From: Bernard, Dana
Sent: Friday, March 15, 2019 10:02 AM
To: mbholsinger@comcast.net
Subject: FW: 1450 Long Corner Road

RE: B18002782
1450 Long Corner Road
Mount Airy, MD 21029

This letter is in response to building permit **B18002782**. The existing system is considered inadequate for your proposed addition. To get started, percolation testing must occur on the property. Please submit a percolation test application, percolation test plan and fee of \$506 to the Health Department. The homeowner will be responsible for hiring an engineer to create a percolation test plan and a septic contractor with a backhoe to dig the percolation test holes.

LIBER 2816 AT FOLIO 547
TAX ID No. 04-306609
1450 LONG CORNER ROAD
FOURTH ELECTION DISTRICT
HOWARD COUNTY, MARYLAND
SCALE: 1"=30' MARCH 2019

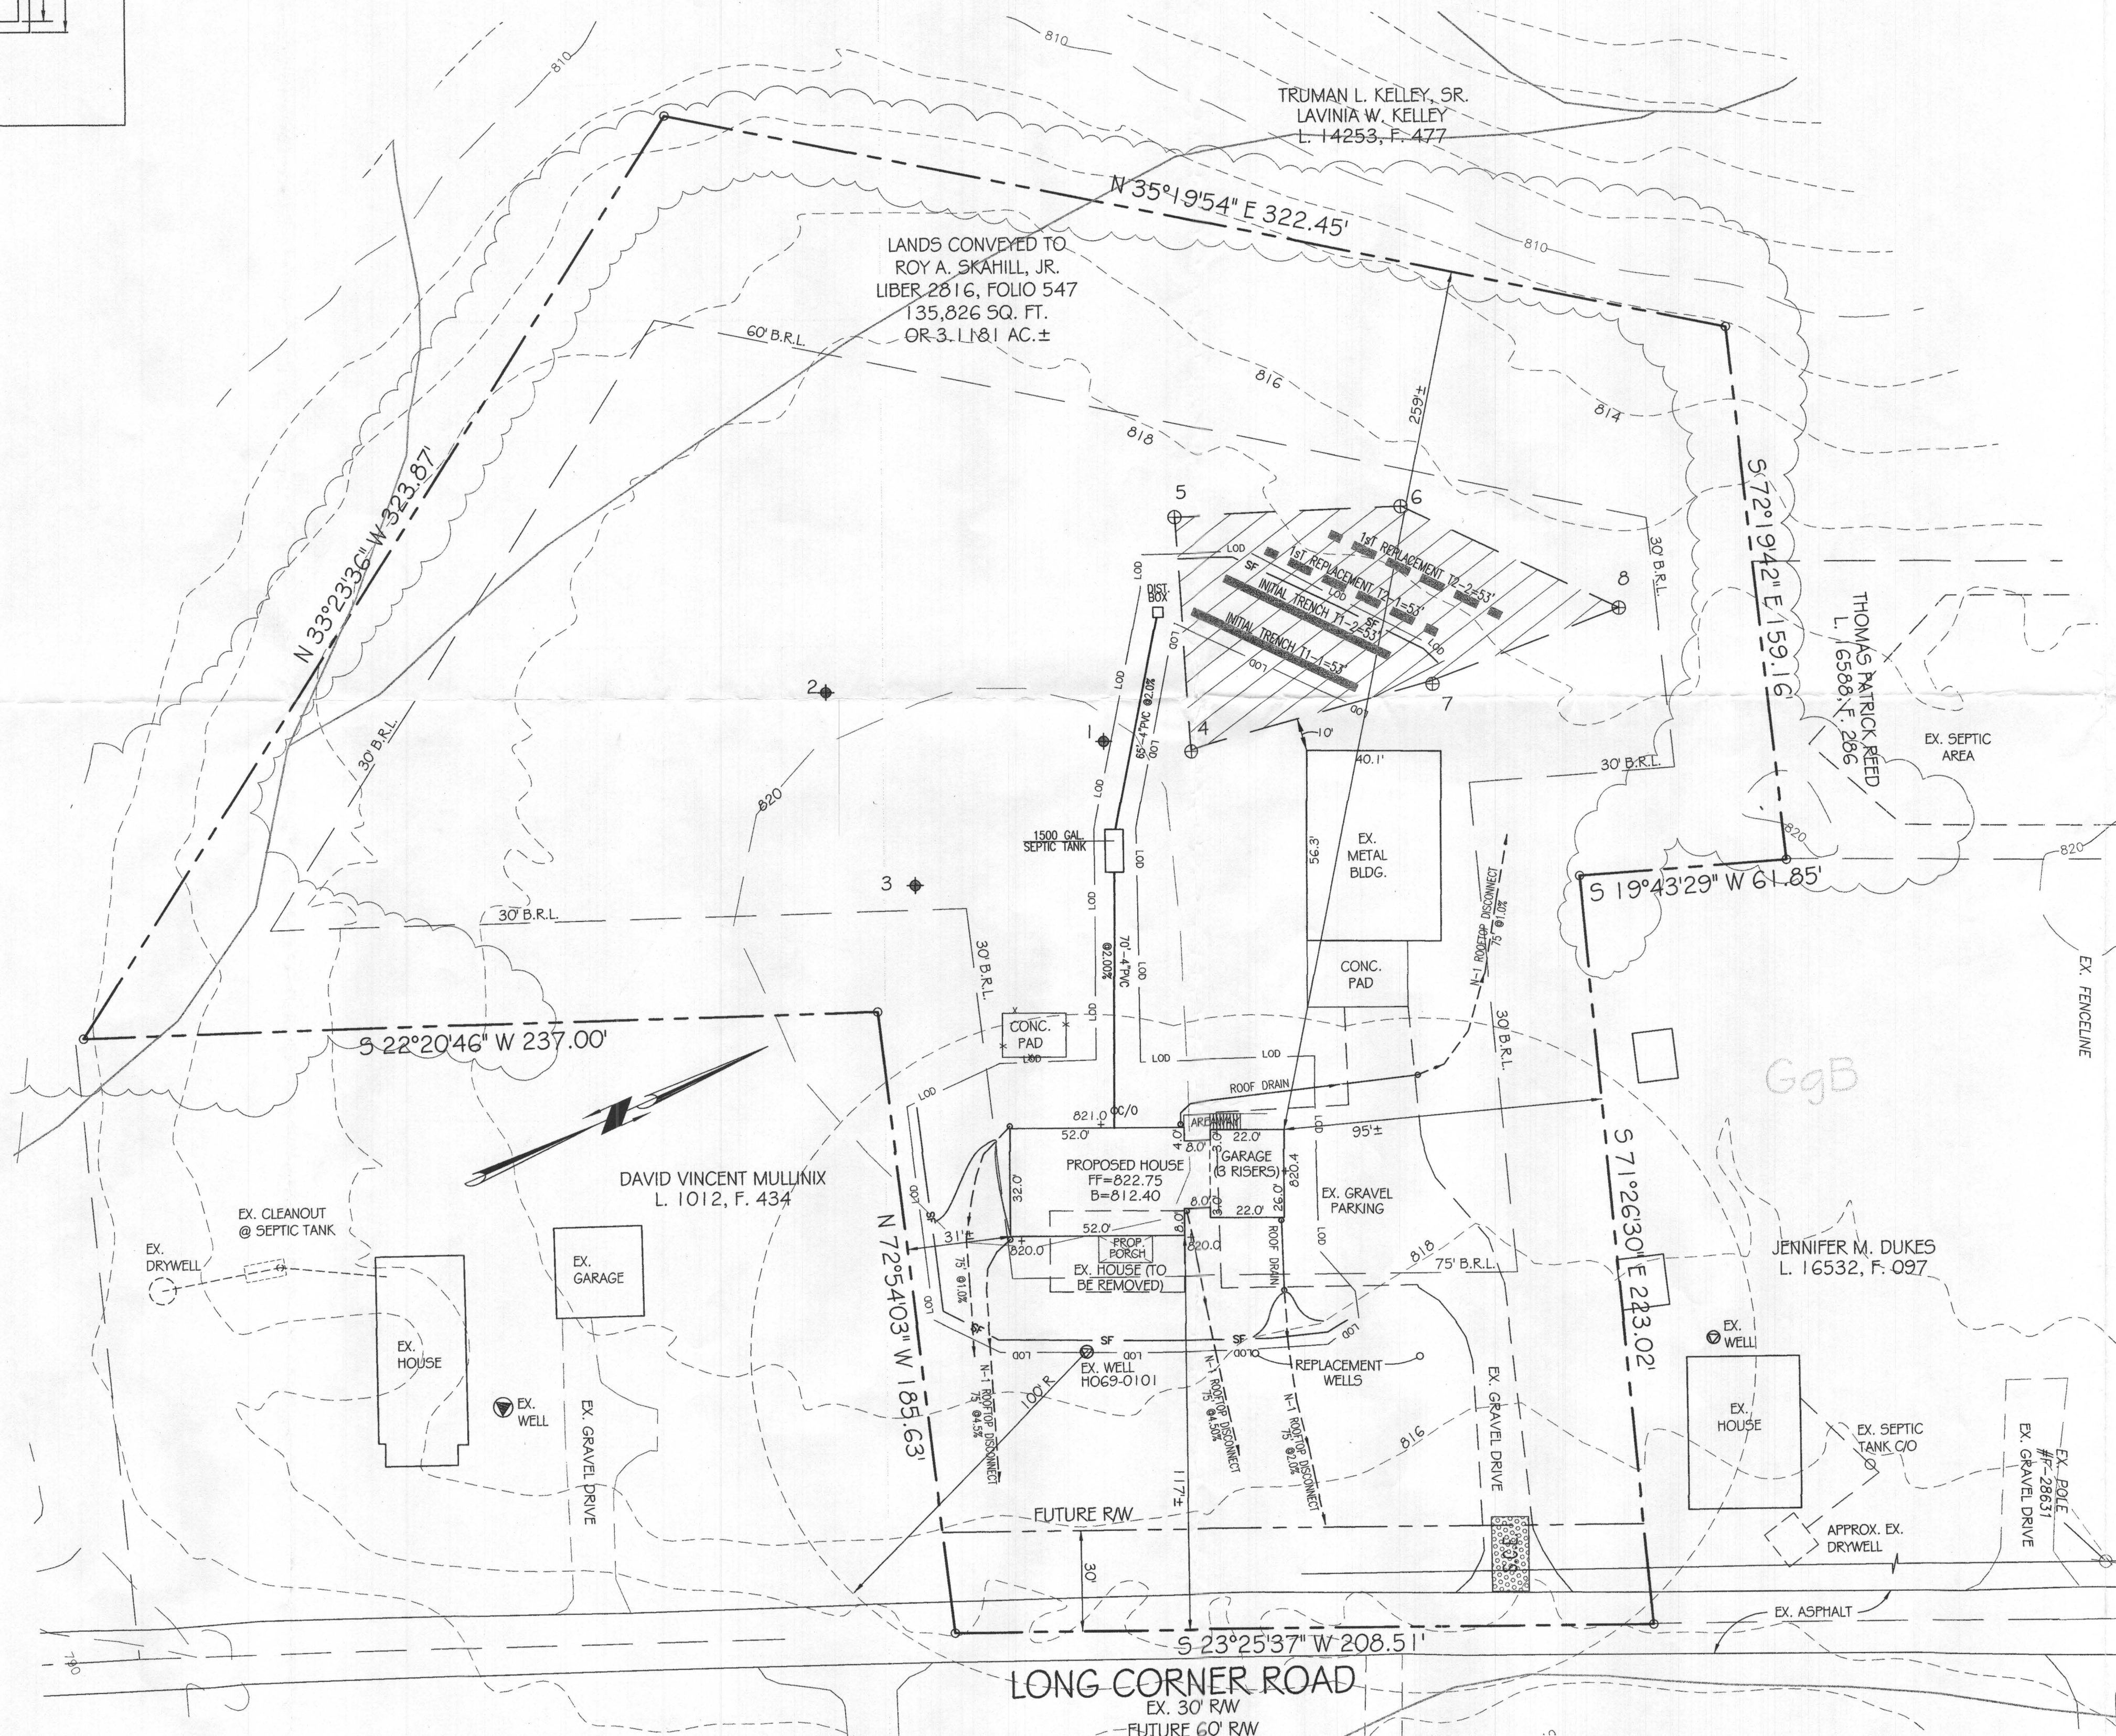
Once the testing is completed a sewage disposal area (SDA) for the proposed house and future repairs must be established on a percolation certification plan." Since a percolation certification plan does not exist for this property, it will have to be created prior to building permit approval (Howard County Code Sec 3.805).

If the onsite well does not meet current regulations, it will have to be brought up to code prior to approval of a building permit. For example, if the well does not have casing extending above grade, the well casing must be extended by a licensed well driller with a pit less adaptor installed. Furthermore, if the well doesn't meet the required 20 foot setback to the house with basement, then the owner will have to ask for a Variance from the Maryland Department of the Environment (MDE) and receive approval prior to making any changes to the well. Please revise site plan to show all septic system components (per As-Built drawing).
